John Almeida

Dwelling Replacement

3604 Fectos Road, Tower Greenwood Township

Proposal Details

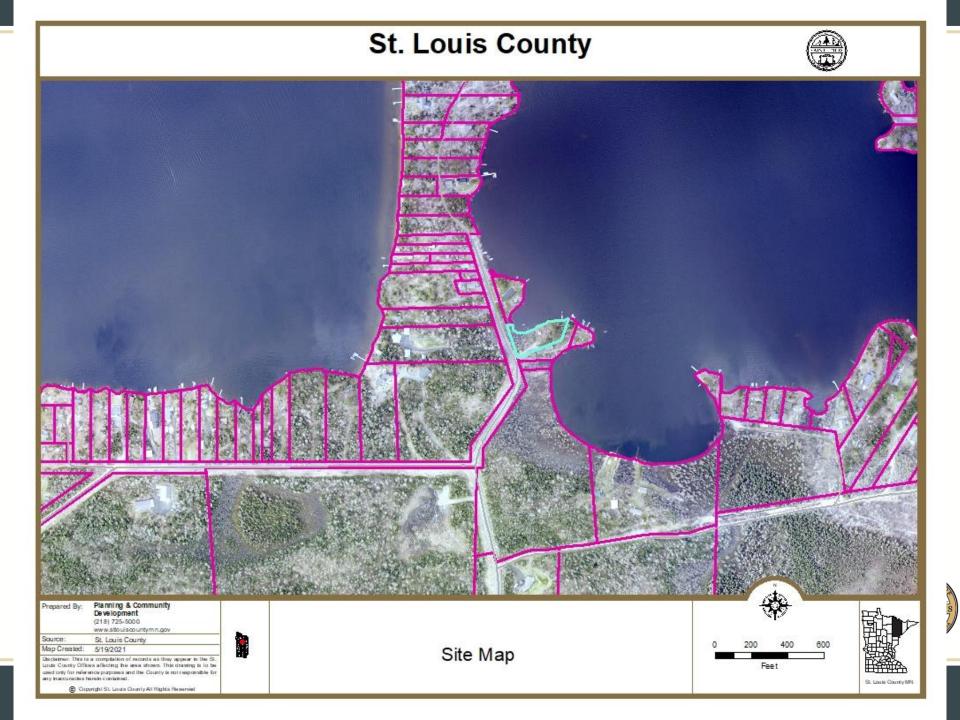
- The current structure is located approximately 36 feet from the shoreline (measured by staff).
- The applicant indicated that the proposed structure would be at the same shoreline setback.
- The existing structure is 647 square feet and 20 feet in height
- The proposed new structure would be 1,536 square feet and 25 feet in height

Development on the property

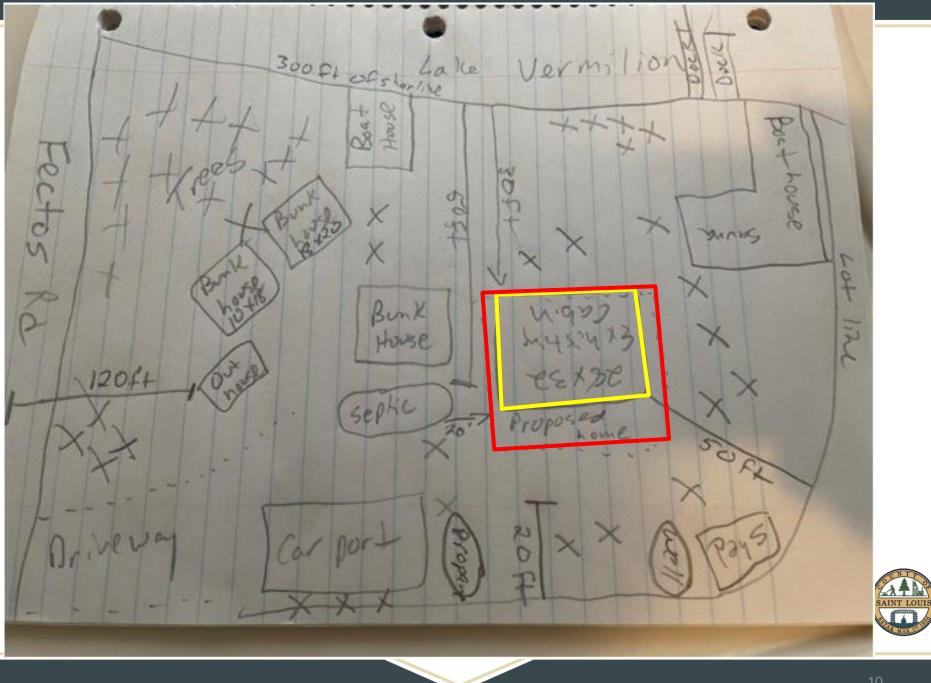
- Existing Dwelling
- Septic Tank
- Well
- Several dilapidated accessory structures
 - Two "boathouses"
 - Three "bunk houses"
 - Shed
 - Sauna
 - Carport
